**GE STOCKHOLDERS' ALLIANCE,
PATRICIA BIRNIE
PAGE 1 OF 1**

Date Received: 06/12/96
 Comment ID: P0048
 Name: Patricia Burney
 Address: GE Stockholder's Alliance

Re: OPPOSITION TO USE OF MIXED OXIDE FUEL FOR
 COMMERCIAL REACTORS

FIGURE 1 (FROM DOE/MD-0002)

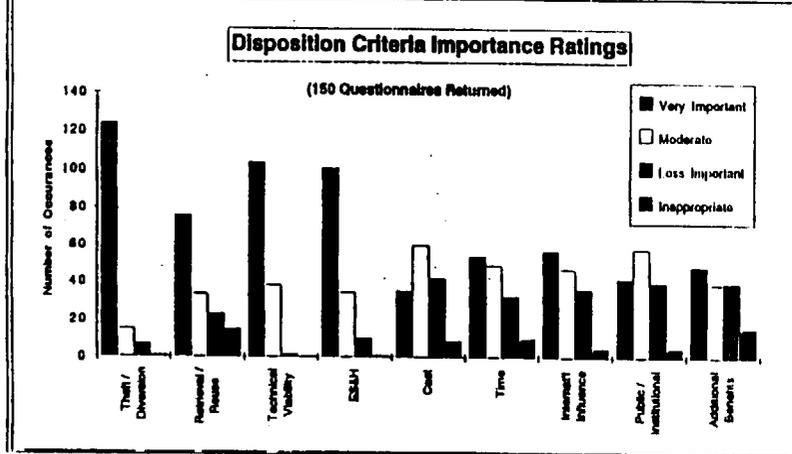
The screening report states that the spent fuel standard was generally accepted, except by "proponents of developmental technologies that could go beyond the spent fuel standard". This statement ignores the letter of December 13, 1994, from Senators Thurmond and Hollings and Representatives Spratt and Spence to Secretary O'Leary that questioned the adequacy of the spent fuel standard. It also continues to ignore the numerous comments in the public scoping meetings which indicated that measures beyond the spent fuel standard would be required to provide ultimate disposition of the plutonium, to ensure that the national security objectives of the plutonium disposition effort would be met, and to extract the maximum possible energy value from the plutonium. The DOE letter of April 14 states that, "all fission options which go beyond the spent fuel standard were deemed unreasonable." By precluding all options that can exceed the spent fuel standard prior to detailed, full evaluation in the PEIS, DOE has withheld important information from
